INVITATION TO BID

Roof Replacement
at
Village at Overlake Station 2580 152nd Ave NE, Redmond, WA 98052

ADDENDUM NO. 1

CONTRACT NUMBER: TS2500931

EZ FLAPPER™ EXHAUST VENT

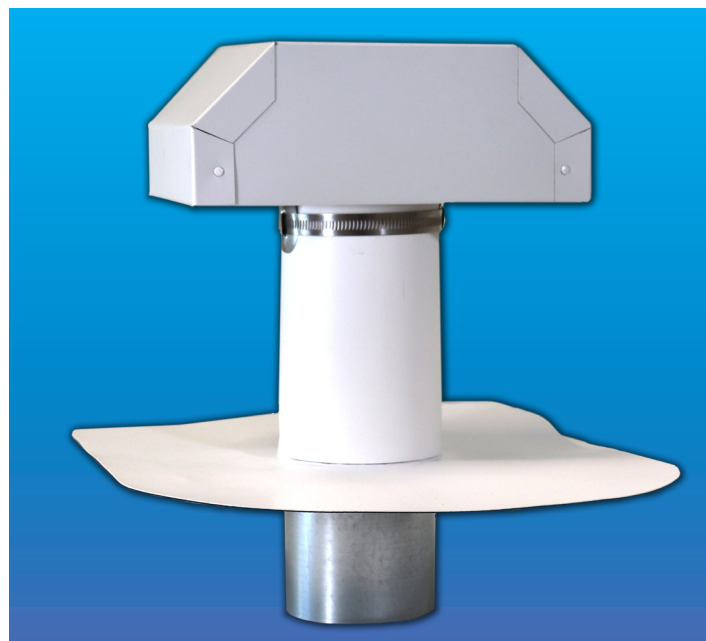
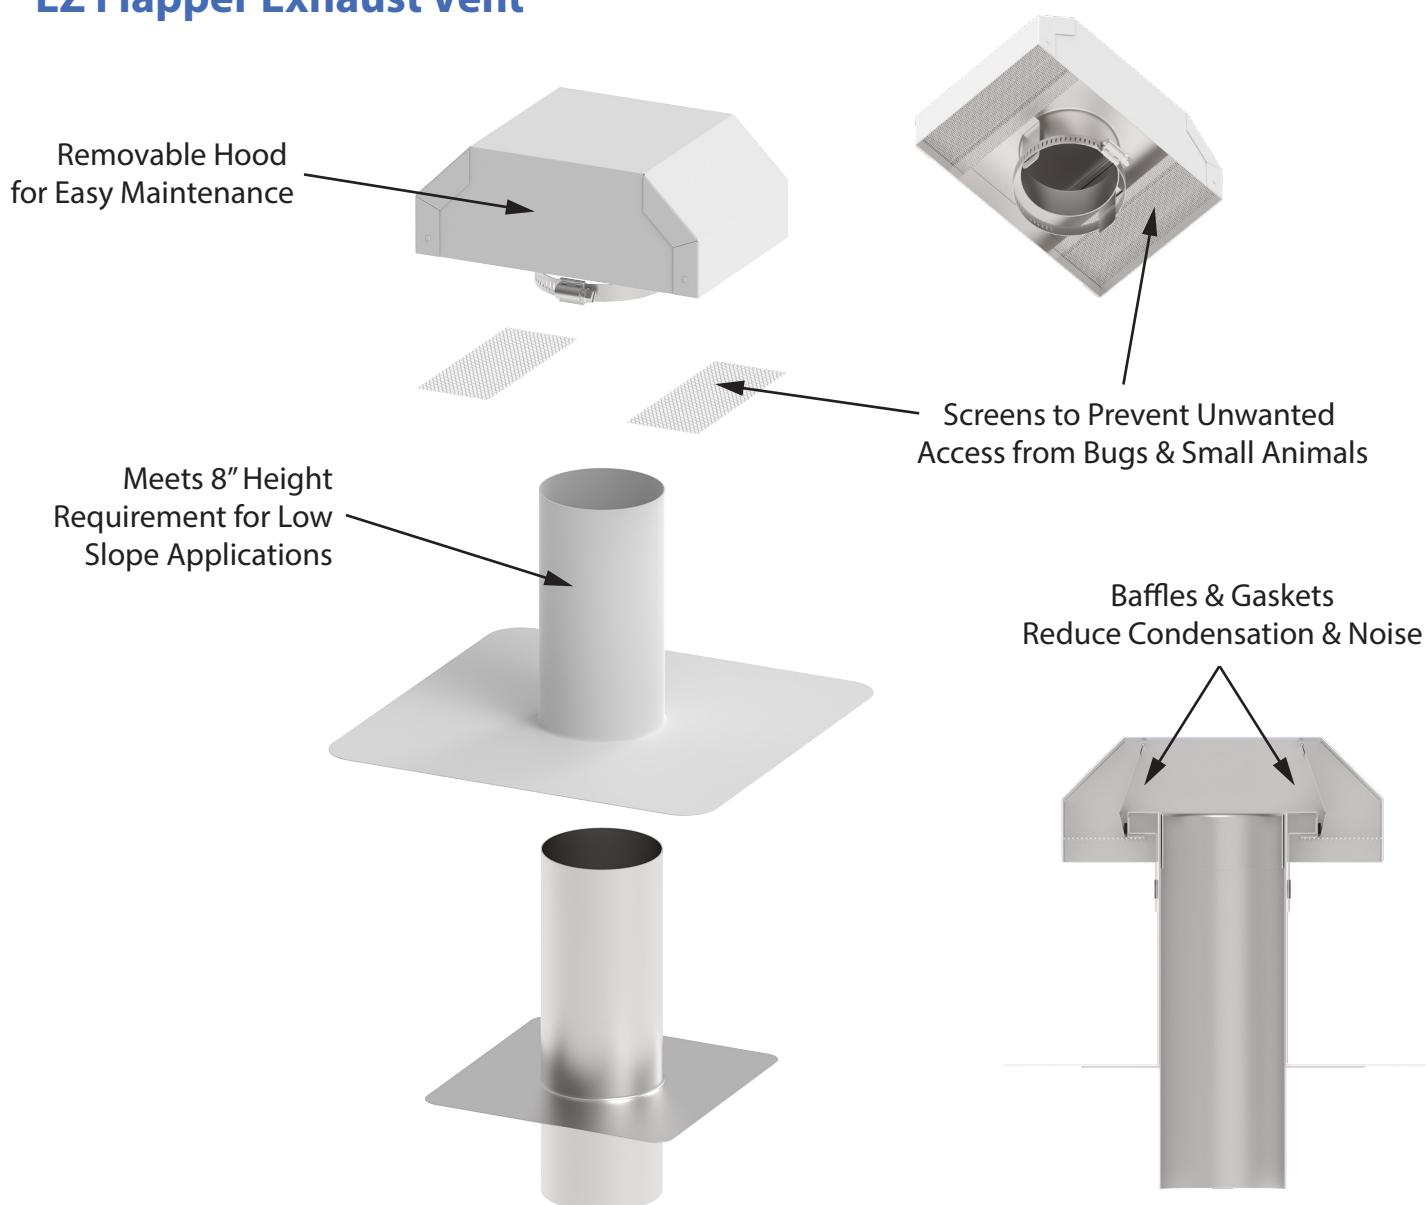
Q2: Detail on sheet 3.1 detail 2 typical vent curb shows a galvanized cap with no location for screen or weather protection. The drawing is only of the section without specification to the cap design. Can you request more information from Pacific Engineering on the details of this item? Plan notes there are 144 on these vents. Cost to have them custom made would be expensive

A2: Drawings show where all the existing roof ventilation penetrations are located, but since we are abandoning a vented roof assembly most of these will no longer be needed. However, there are exhaust vents for bathroom, kitchens, and dryers intermingled. We don't know which ones they are or where these are

located. It is likely that all the top floor units vent through the roof. Contractors to provide a cost for 69 vents (3 per unit at 23 units). Contractor to provide unit cost (unit price no. 5) for deduct or addition as required. Vents to provide a tight connection, and a clear ducting path with backdraft louvers, such as: FlashVent EZ Flapper Exhaust Vent or similar (See page 5 & 6).
